DOCKETED
12-AAER-2C

RE: Invitation to Submit Proposals - 2012-2013 Appliance Efficiency Rulemaking Water Appliances – Docket No. 12-AAER-2C

Input to the California HCD Focus Group on proposed 2013 CALGreen changes with respect to water conservation.

Subject: 2013 CALIFORNIA GREEN BUILDING STANDARDS CODE CALIFORNIA CODE OF REGULATIONS, TITLE 24, PART 11

Source: IAPMO

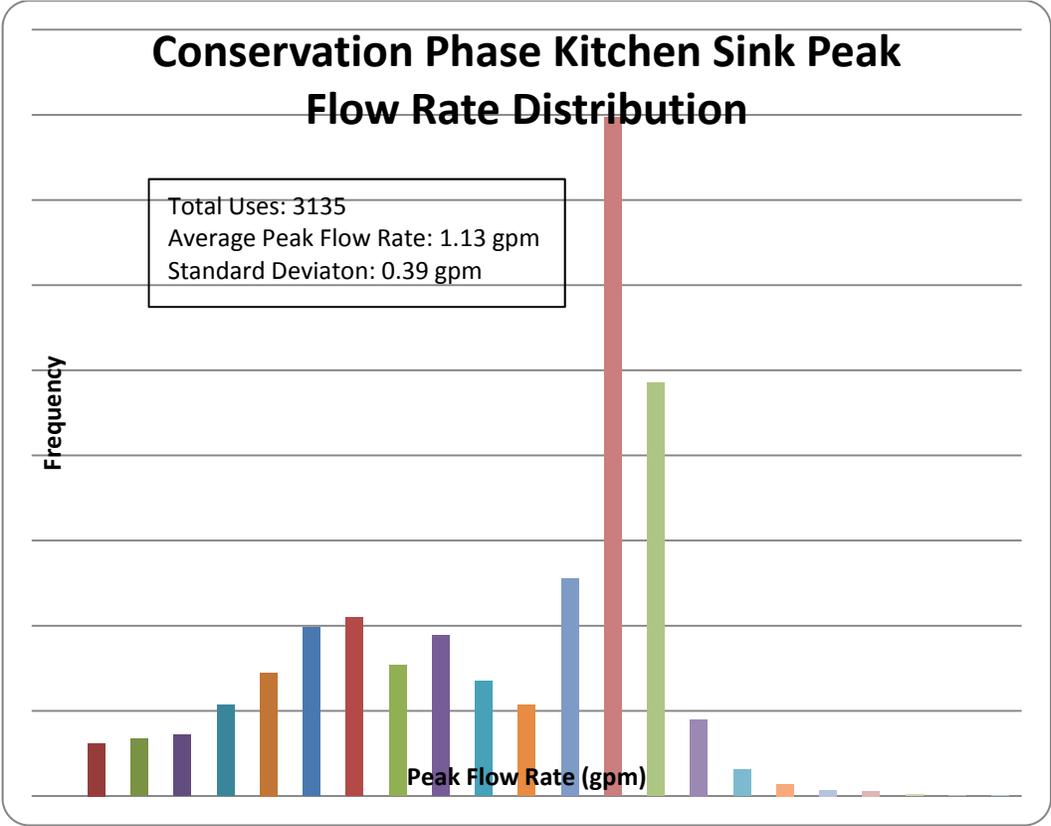
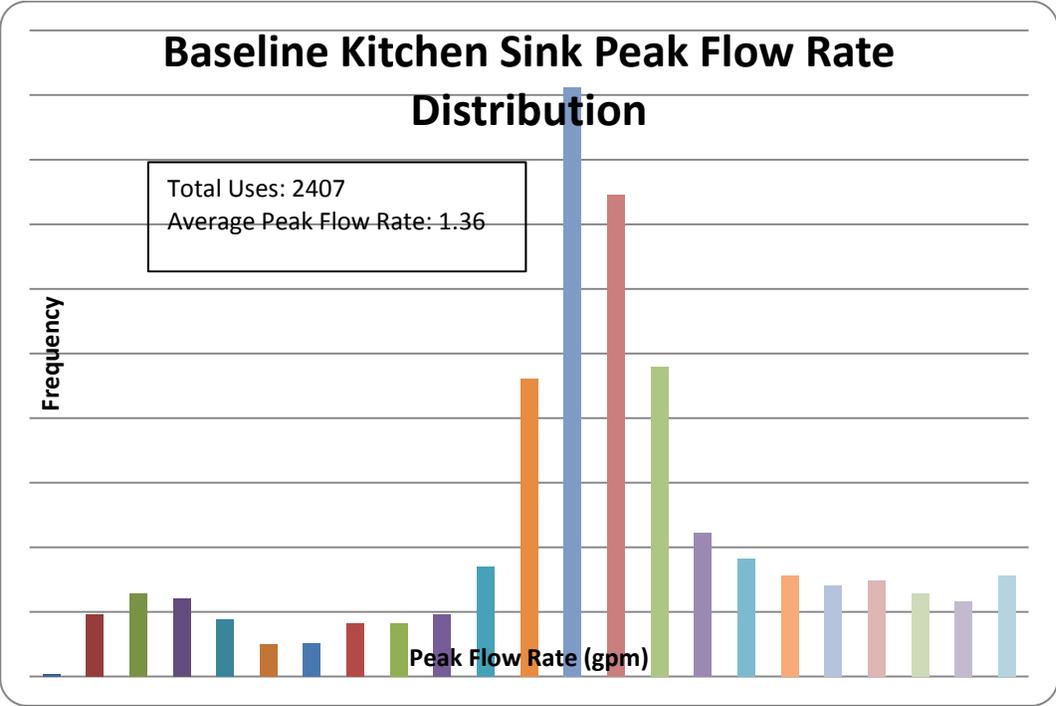
Our Home Water Use data suggest from the frequency/flow rate histogram that the average flow rate over the conservation phase of the study, where lavatory faucets were restricted to 1.5 gpm, was actually 1.2 gpm. The number of uses/capita/day average was 18.4 at an average time of 0.21 minutes/use: $(1.2 \times 18.4 \times 0.21 = 4.6$ gallons/capita/day average. The formula in the CALGreen table would calculate $1.8 \times 4 \times 1 = 7.2$ gallons/capita/day average, which significantly overstates the baseline value.

For Showers, the CALGreen table baseline is: $2.0 \times 8 \times 1 = 16$ gallons/capita/day. Our study indicates that for a 2.5 gpm showerhead limit, the average flow rate in use was about 2.3 gpm, or about 92% of full flow. For a 2.0 gpm showerhead, we could likewise assume a real flow rate of 1.84 gpm on average. Using the CALGreen table's assumptions of 1 shower/person/day and the 8 minute shower, the baseline should actually be: $1.84 \times 8 \times 1 = 14.72$ gallons/capita/day.

3 – The missing piece is this draft proposal is the need for consumer research. The attached charts are a snapshot of real world consumer usage and have been used in the development of voluntary standards such as WaterSense.

For the above reasons, we would ask that the appendix on voluntary flow rate standards be removed from the 2013 CalGreen draft regulations.
